AINSLEY WOODS SUBDIVISION

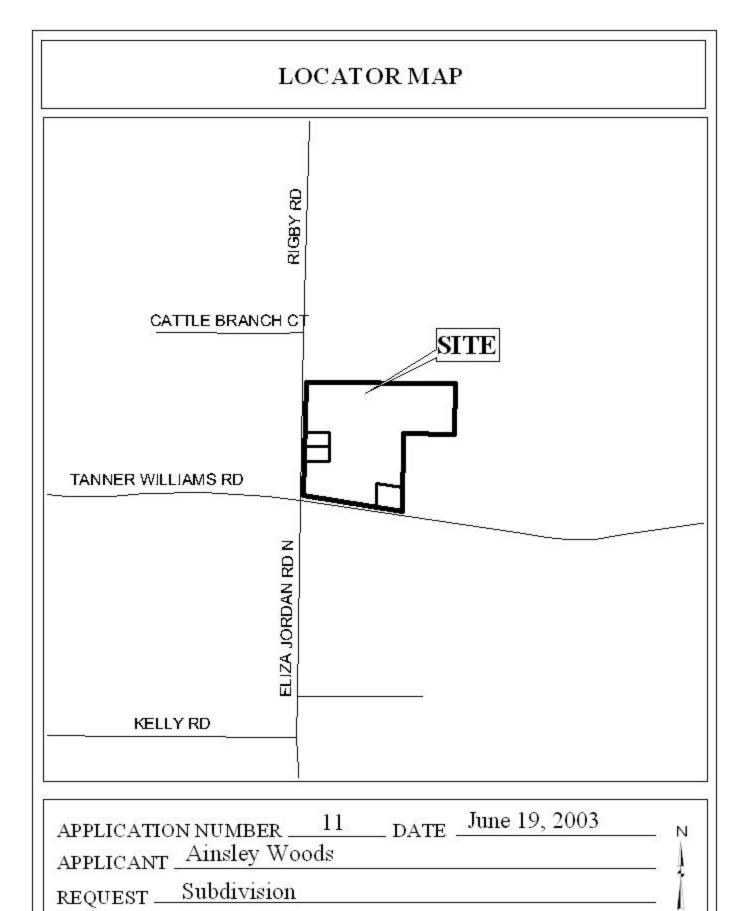
<u>Engineering Comments</u>: Must comply with the Mobile County Flood Damage Prevention Ordinance.

The site fronts Eliza Jordon Road (Rigby Road) a planned major street and the existing right-of-way is shown as 50 feet; the Major Street Plan requires a 100-foot right-of-way. Therefore, the provision of a 75-foot setback (which includes the required minimum building setback of 25-feet) from the centerline of Eliza Jordon Road, to provide for the right-of-way of the planned major street, should be required. Additionally, as a means of access management, a note should be placed on the final plat stating Lots 1 and 2 are limited to one curb cut each to Eliza Jordon Road, with the size, location and design to be approved by County Engineering.

This site is located in the County, thus a note should be placed on the final plat stating that any lots which are developed commercially and adjoin residentially developed property must provide a buffer, in compliance with Section V.A.7. of the Subdivision Regulations.

With modifications, the plat will meet the minimum requirements of the Subdivision Regulations and is recommended for Tentative Approval subject to the following conditions: 1) the provision of a 75-foot setback (which includes the required minimum building setback of 25-feet), from the centerline of Eliza Jordon Road; 2) placement of a note on the final plat stating that Lots 1 and 2 are limited to one curb cut each to Eliza Jordon Road, with the size, location and design to be approved County Engineering; and 3) the placement of a note on the final plat stating that any property that is developed commercially and adjoins residentially developed property shall provide a buffer, in compliance with Section V.A.7. of the Subdivision Regulations.
